Access Compliance Report

Public Rights-of-Way

Intersection ID: N/A	Main Street: SOUTH_BV	Cross Street: HEBRON_ST	Location: NE
ADA ID: 6EF81C83B7AF	Ramp Type: Perp	Initial Pass/Fail: Fail	Overall Compliance: No
Severity Score: 12.5			
Codes/Mitigation Info/Possible Solution		Field Measurements/Component Compliance

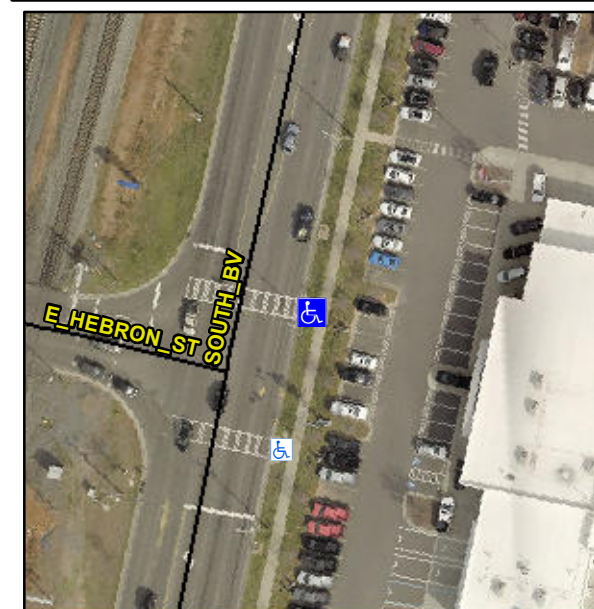
R304.2.2

Compliance	Description	Data	Compliance	Description	Data
N/A	Ramp Length (in)	96.0	No	Ramp Slope (%)	8.6
Yes	Ramp Width (in)	60.0	Yes	Ramp XSlope (%)	1.1
N/A	Flare Type LT	N/A	N/A	Flare Type RT	N/A
N/A	Flare Slope LT (%)	N/A	N/A	Flare Slope RT (%)	N/A
N/A	Flare Traversable LT?	N/A	N/A	Flare Traversable RT?	N/A
N/A	Landing Length (in)	N/A	N/A	DWS Provided?	N/A
N/A	Landing Width (in)	N/A	N/A	DWS Contrast?	N/A
N/A	Landing Slope (%)	N/A	N/A	DWS Length (in)	N/A
N/A	Landing X Slope (%)	N/A	N/A	DWS Full Width?	N/A
N/A	Landing Curb? (Y/N)	N/A	N/A	DWS Offset (in)	N/A
N/A	Shared Landing?	N/A			
N/A	Gutter Ponding?	N/A	N/A	Gutter Slope (%)	N/A
N/A	Gutter Lip Ht (in)	N/A	N/A	Gutter X Slope (%)	N/A
N/A	Painted X Walk1?	Yes	N/A	Painted X Walk2?	N/A
	X Walk 1 Direction	To W		X Walk 2 Direction	N/A
N/A	X Walk 1 Width (in)	114.0	N/A	X Walk 2 Width (in)	N/A
	X Walk 1 Slope (%)	4.5		X Walk 2 Slope (%)	N/A
	X Walk 1 X Slope (%)	0.7		X Walk 2 X Slope (%)	N/A

Remove & Replace Entire Ramp.

Total Cost: \$ 1850.00
